Access Compliance Report

Public Rights-of-Way

Intersection ID: 29793	Main Street: BRISTLE_TOE_LN	Cross Street: DESTIN_LN	Location: SW
ADA ID: 0C5717D9C59A	Ramp Type: PerpDiag	Initial Pass/Fail: Fail	Overall Compliance: No
		Severity Score: 50

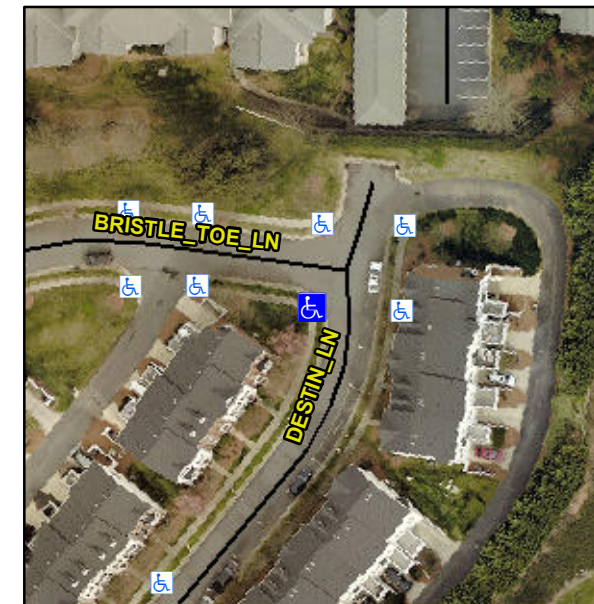
R304.2.2, R304.5.3

Compliance	Description	Data	Compliance	Description	Data
N/A	Ramp Length (in)	96.0	No	Ramp Slope (%)	12.3
Yes	Ramp Width (in)	48.0	No	Ramp XSlope (%)	7.5
N/A	Flare Type LT	N/A	N/A	Flare Type RT	N/A
N/A	Flare Slope LT (%)	N/A	N/A	Flare Slope RT (%)	N/A
N/A	Flare Traversable LT?	N/A	N/A	Flare Traversable RT?	N/A
N/A	Landing Length (in)	N/A	N/A	DWS Provided?	N/A
N/A	Landing Width (in)	N/A	N/A	DWS Contrast?	N/A
N/A	Landing Slope (%)	N/A	N/A	DWS Length (in)	N/A
N/A	Landing X Slope (%)	N/A	N/A	DWS Full Width?	N/A
N/A	Landing Curb? (Y/N)	N/A	N/A	DWS Offset (in)	N/A
N/A	Shared Landing?	N/A			
N/A	Gutter Ponding?	N/A	N/A	Gutter Slope (%)	N/A
N/A	Gutter Lip Ht (in)	N/A	N/A	Gutter X Slope (%)	N/A
N/A	Painted X Walk1?	No	N/A	Painted X Walk2?	No
	X Walk 1 Direction	To SE		X Walk 2 Direction	To NE
N/A	X Walk 1 Width (in)	N/A	N/A	X Walk 2 Width (in)	N/A
	X Walk 1 Slope (%)	3.0		X Walk 2 Slope (%)	3.9
	X Walk 1 X Slope (%)	2.5		X Walk 2 X Slope (%)	0.1

Remove & Replace Curb Ramp With Two New Directional Ramps or Equivalent.
